Docket No. 50-537
HQ:S:82:151

INSTRUMENTATION (CHAPTER 7) WORKING MEETINGS - ADDITIONAL INFORMATION

Instrumentation and Control (Chapter 7) September 21 and 22, and
November 18 and 19 Working Meetings Action Items due to NRC
December 10, 1982

7.3-23
 FIGURE 7-6-37 CONTROL ROOM FILTER UNIT FAN
 FUNCTIONAL CONTROL DIAGRAM TYPICAL-FLOW-
 MODULATED-VORTEX-DAMPER—
 INLET VANE MODULATION

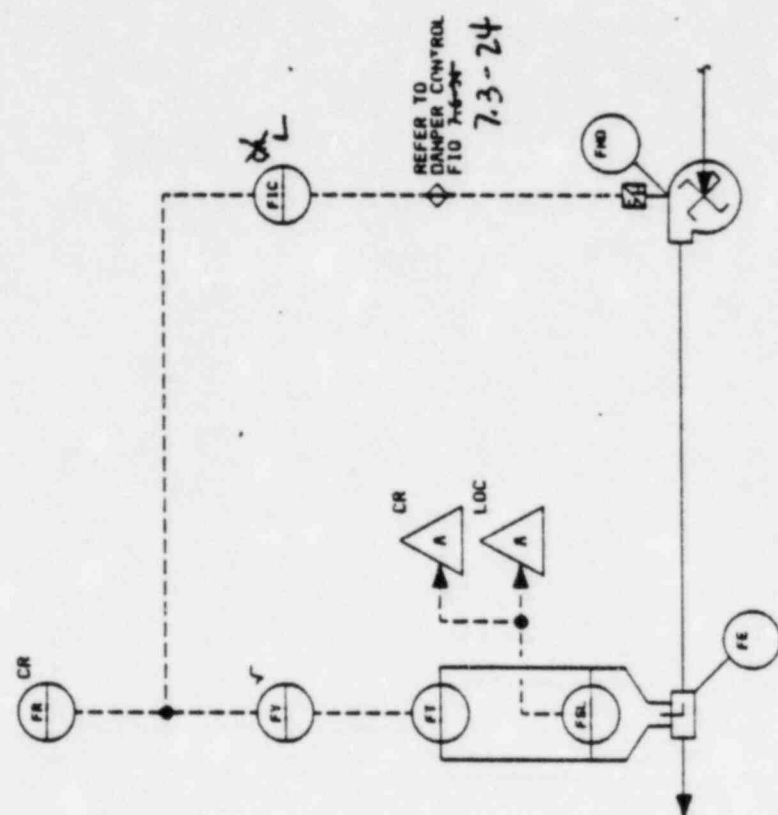
Additional information for Item 32 of the December 6 submittal.
